Report to the Plan Commission

Legistar I.D. #28589
1127 North Sherman Avenue
Conditional Use Request

Requested Action: Approval of the construction of a single-tenant commercial building within the parking lot of a planned commercial site, which requires conditional use review in the C2 (General Commercial) District.

Figure I-10: Conceptual Designs for the Northgate - Kraft/Oscar Mayer Area.

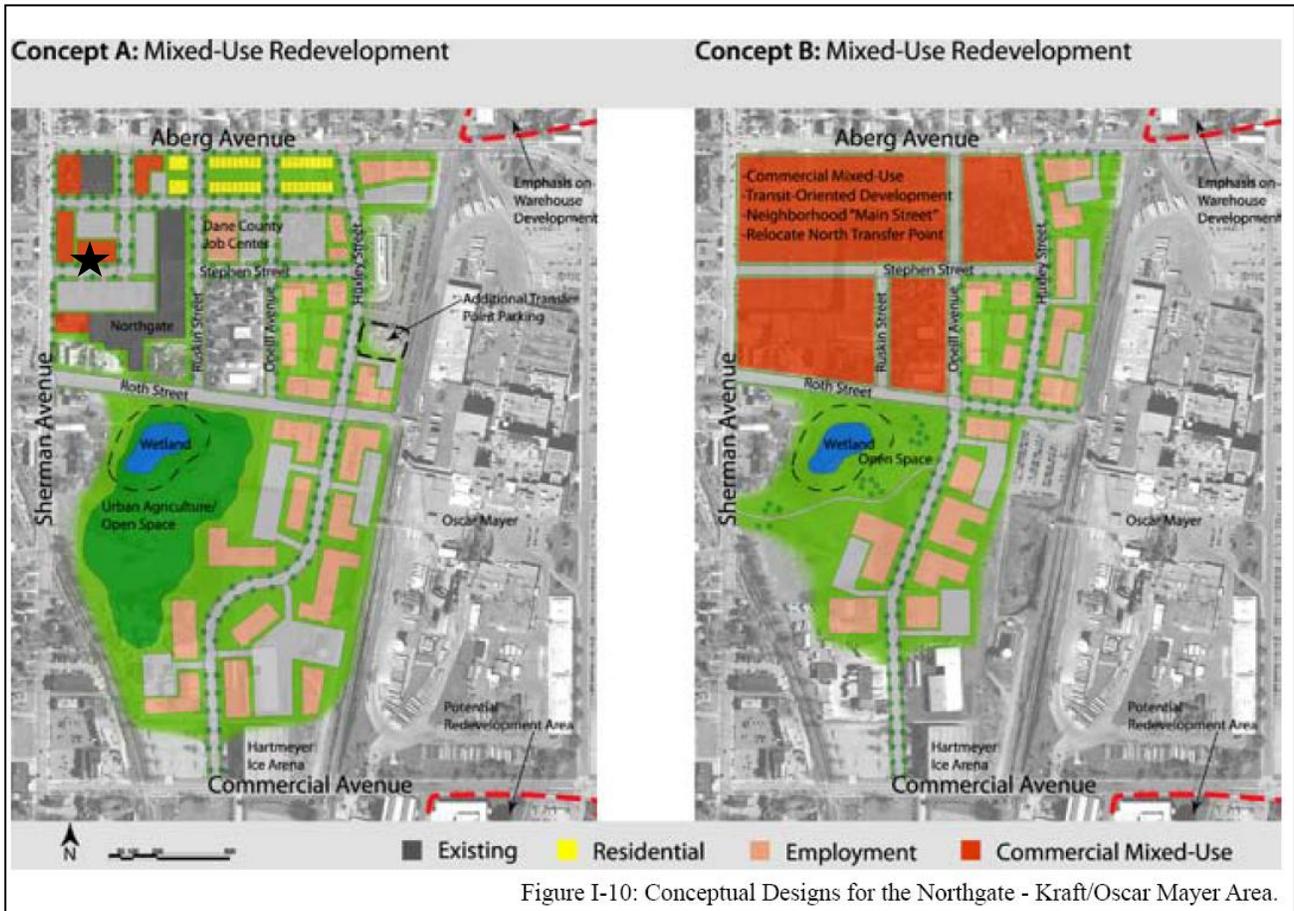
Further, the addition of this building would not preclude opportunities for significant redevelopment of this area as recommended in the Northport-Warner Park-Sherman Neighborhood Plan. Actually, its placement adjacent to a driveway entrance to the shopping center is generally consistent with one of the conceptual designs for mixed-use redevelopment provided in the plan (see Concept A below).
